**HISTORIC ARCHITECTURAL REVIEW BOARD
CITY OF ALLENTOWN, PENNSYLVANIA
October 5, 2020**

FINAL REVIEW

631 W Allen Street (Case # HDC-2020-000033)

Address: 1130 W Chew Street (HDC-2020-00040) – Proposes to do various façade repairs and improvements

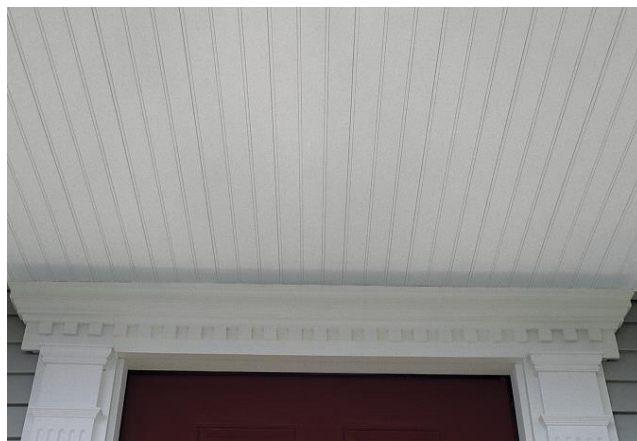
Evaluation, effect on historic district, recommendations: The proposed work is historically appropriate with some modifications and clarifications.

- The front porch roof should be the same slope as existing when reconstructed.
- The porch posts and railings should reference the neighboring properties. One way to do that might be a rectilinear version of them. The posts could be 6 x 6 with chamfered corners above the railing. The railing could be a square version of the neighbor's with a lower section of 2 x 2 balusters, intermediate horizontal, upper section of 2 x 2 balusters offset from the lower and top and bottom rails.

- The beaded ceiling material in vinyl might be an acceptable option if a larger panel. The attached specification is a small panel size and would have many joints. CertainTeed has a beaded soffit material (Beaded Triple 2") that would be historically appropriate and avoid the joints. It is available also with invisible vents if ventilation needed.

- Replacing vinyl windows with vinyl windows is acceptable by Ordinance.
- Replacing the concrete stoop to match is historically appropriate. Bull nose treads should be recreated. The proposed steep handrail should have a shaped top rail and lamb's tongue terminations.

1. The proposal to do repairs to the front wall and porch at 1130 W Chew Street was represented by Heidi Westerman.
2. The front porch roof, supports, and floors will be completely removed and replaced with like material with the exception of the porch guardrails (pipe railings) and porch ceiling.

3. The floor will have 1 x 3 wood decking, painted.
4. The porch posts will be replaced with new turned wood posts that match the porch posts of the neighboring porch.

5. The handrails will be replaced with wood top and bottom rails with turned balusters to match the neighboring porch railing.
6. A wood end gable matching the historic will be installed.

7. The porch ceiling will be replaced with vinyl bead board.
8. The deteriorated front concrete stairs will be demolished and reconstructed with bull nose treads. A new, traditional, steel handrail with lamb's tongue terminations will be installed on the new steps to meet code.

9. Two existing vinyl windows will be replaced with new vinyl windows. The size of the window on the left will be increased to fit the historic opening.

10. Half-round gutters and round downspouts will be installed.
